Draft Amendment to Regulation No. 117

PROPOSAL TO ADD TYRE ADHESION PERFORMANCES TO UNECE REGULATION No. 117
Document TRANS/WP.29/GRRF/2005/11/Rev.1

Example 2, amend to read:

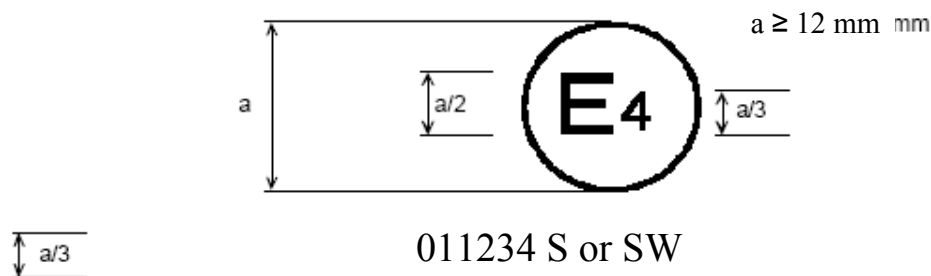
The above approval mark shows that the tyre concerned has been approved in the Netherlands (E4) pursuant to Regulation No. 117 (marked by S (rolling sound) or both S (rolling sound) and W (wet adhesion), under approval number 011234. This indicates that the approval is for S or both SW. The first two digits of the approval number (01) indicate that the approval was granted according to the 01 series of amendments."

Example 3 amend to read:

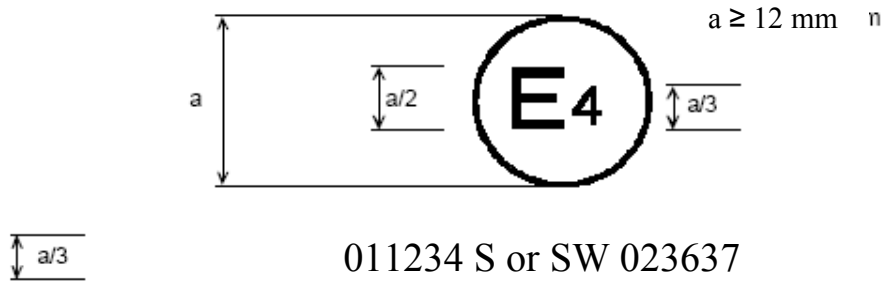
The above approval mark shows that the tyre concerned has been approved in the Netherlands (E4) pursuant to Regulation No. 117 (marked by S (rolling sound) or SW (rolling sound and wet adhesion), under approval number 011234. This indicates that the approval is for S or SW. The first two digits of the approval number (01) indicate that the approval was granted according to the 01 series of amendments, but Regulation No. 30 included the 02 series of amendments.

Example 4 amend to read:

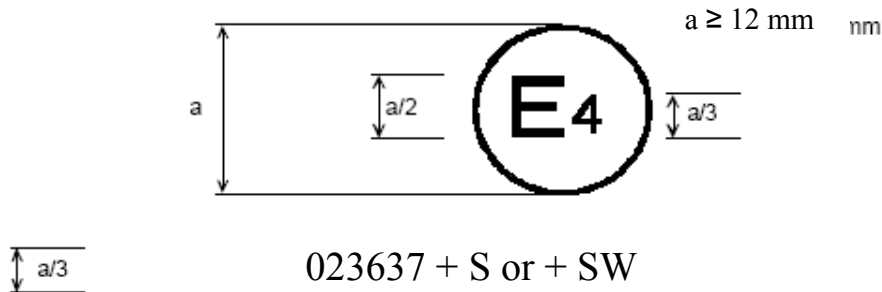
The above approval mark shows that the tyre concerned has been initially approved in the Netherlands (E4) pursuant to Regulation No. 30 and the 02 series of amendments under approval number 023637. It is also marked by + S (rolling sound) or + SW (rolling sound and wet adhesion) which indicates that it has had its approval extended under Regulation No. 117. This indicates that the approval is for S or SW. The first two digits of the approval number (02) indicate that the approval was granted according to Regulation No. 30 which included the 02 series of amendments. The addition (+) sign indicates that the first approval was granted in accordance with Regulation No. 30 and has been extended to include Regulation No. 117 approval(s).

Example 5

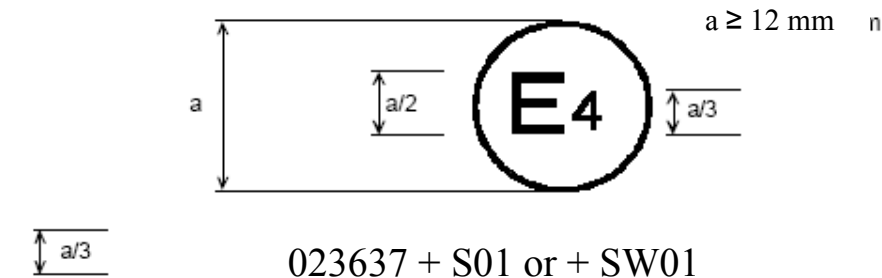
The above approval mark shows that the tyre concerned has been initially approved in the Netherlands (E4) pursuant to Regulation No. 30 and the 02 series of amendments under approval number 023637. This indicates that the approval is for S (rolling sound) or S (rolling sound) and W (wet adhesion). The S or SW followed by (01) indicates that it has had its approval extended under Regulation No. 117 which included the 01 series of amendments. The first two digits of the approval number (02) indicate that the approval was granted according to Regulation No. 30 which included the 02 series of amendments. The addition (+) sign indicates that the first approval was granted in accordance with Regulation No. 30 and has been extended to include Regulation No. 117 approval(s).

Example 6 amend to read:

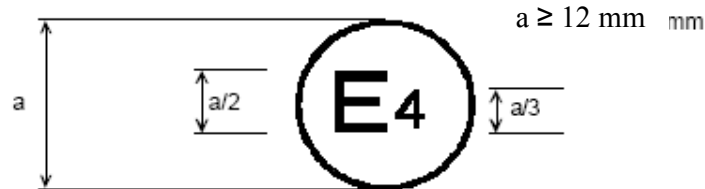
The above approval mark shows that the tyre concerned has been approved in the Netherlands (E4) pursuant to Regulation No. 117 and the 01 series of amendments under approval number 011234 (marked by S only), and Regulation No. 54. This indicates that the approval is for rolling sound (S) only, as Regulation 54 approved tyres at present cannot be approved for wet adhesion. The first two digits of the Regulation 117 approval number (01) in conjunction with 'S' indicate that the first approval was granted in accordance with Regulation 117 which included the 01 series of amendments. The first two digits of Regulation 54 (00) indicates that this Regulation was in its original form.
